Product Change Notification

113525 - 00

Change Notification #: 113525 - 00
Change Title: Intel® Server System R2208GZ4GS9
PCN 113525-00, Product Design
Update the System Rear Panel and
BIOS/ME/BMC/FRUSDR Firmware
Date of Publication: December 17, 2014

Figure One

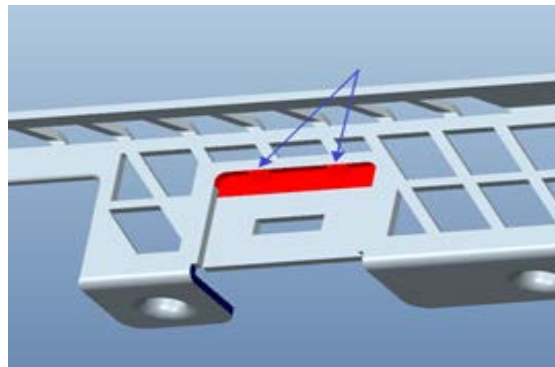
1. Update the one big center joint to two smaller joints so that the joints will not conflict with the LAN cable connector latch. See the Figure One.

Figure Two

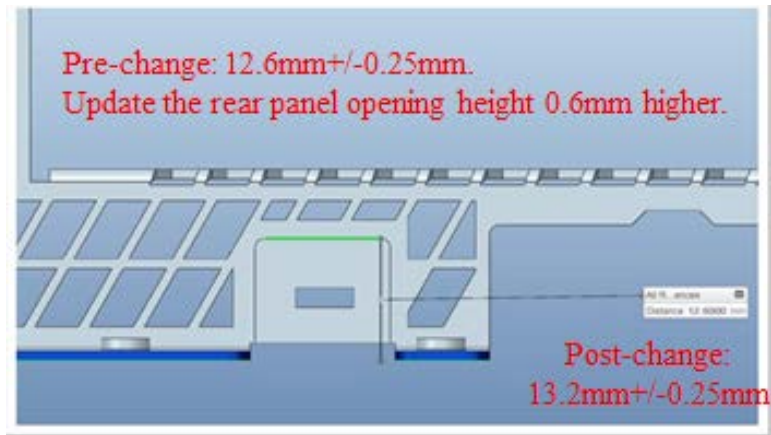
2. Update the rear panel opening height 0.6mm higher to improve the flexibility for the cable latch. The previous height was 12.6mm \pm 0.25mm. The updated height is 13.2mm \pm 0.25mm. See the Figure Two.

Figure Three

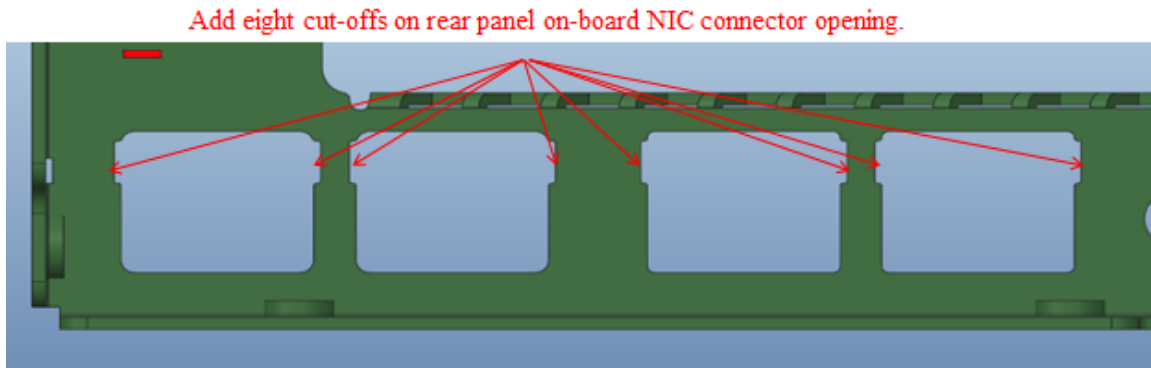
3. Add eight cut-offs around the on-board NIC (Network Interface Controller) openings to improve the LED visibility. See Figure Three.
